10/590,638

Office Action Summary	Application No. 10/590,638	Applicant(s) RAMSAUER, DIETER	
	Examiner KRISTINA R. FULTON	Art Unit 3673

DETAILED ACTION

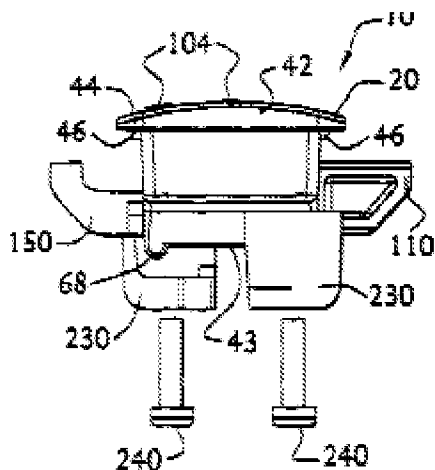
16. Claims 28-29, 31 and 34 are rejected under 35 U.S.C. 102(b) as being anticipated by Vickers (US 6145352).
17. Regarding claims 28, 31 and 34, Vickers teaches a latch having a head part (42) arranged outside a thin wall, a body part (20 below 42) which proceeds from the head part and projects through the opening in the mounted position, holding elements (110 and 150) which project from the body part and are flexible in a direction, a free end of the holding elements being provided with an inclined surface (see figure 3), the body

part and the holding elements being separate parts and the holding elements being slides. Please note "as best understood" for the last limitation of claims 28 and 31 and claim 34, Vickers shows a lock cylinder (200) associated with holding elements (110 and 150).

18. Regarding claim 29 "as best understood", Vickers shows the slides are held against a pressure spring force (198) by a hook arrangement (tabs and slots seen in figures 9 and 10).

19. Regarding claim 31, Vickers teaches the claimed limitations as applied to claim 28 above and further teaches "as best understood" that a slides are held by a spring force (198) and a pin arrangement (tabs and slots of figures 9 and 10). See the Vickers device below.
